## Access Compliance Report Public Rights-of-Way (Curb Ramps)

Intersection ID: 10031842Main Street:MINTWORTH\_AVCross Street: N/ANEADA ID: A2DEAAAE00CDRamp Type:PerpInitial Pass/Fail: FailOverall Compliance: NoSeverity Score:12.5

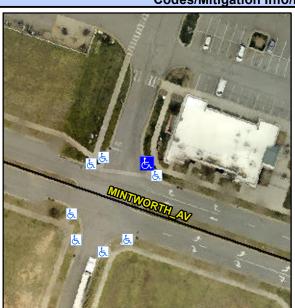
Comp	liance Description	Data		liance Description	Data
N/A	Ramp Length (in)	70.0	No	Ramp Slope (%)	8.5
Yes	Ramp Width (in)	48.0	Yes	Ramp XSlope (%)	1.0
N/A	Flare Type LT	N/A	N/A	Flare Type RT	N/A
N/A	Flare Slope LT (%)	N/A	N/A	Flare Slope RT (%)	N/A
N/A	Flare Traversable LT?	N/A	N/A	Flare Traversable RT?	N/A
N/A	Landing Length (in)	N/A	N/A	DWS Provided?	N/A
N/A	Landing Width (in)	N/A	N/A	DWS Contrast?	N/A
N/A	Landing Slope (%)	N/A	N/A	DWS Length (in)	N/A
N/A	Landing X Slope (%)	N/A	N/A	DWS Full Width?	N/A
N/A	Landing Curb? (Y/N)	N/A	N/A	DWS Offset (in)	N/A
N/A	Shared Landing?	N/A			
N/A	Gutter Ponding?	N/A	N/A	Gutter Slope (%)	N/A
N/A	Gutter Lip Ht (in)	N/A	N/A	Gutter X Slope (%)	N/A
N/A	Painted X Walk1?	No	N/A	Painted X Walk2?	N/A
	X Walk 1 Direction	To NW		X Walk 2 Direction	N/A
N/A	X Walk 1 Width (in)	N/A	N/A	X Walk 2 Width (in)	N/A
	X Walk 1 Slope (%)	0.7		X Walk 2 Slope (%)	N/A
	X Walk 1 X Slope (%)	2.0		X Walk 2 X Slope (%)	N/A

OSSIDIE SOIULIOII					
Possible Solutions:					
Remove & Replace Entire Ramp.					
•					
Surveyor Notes:					
N/A					
PROW/ADA:					
R304.2.2
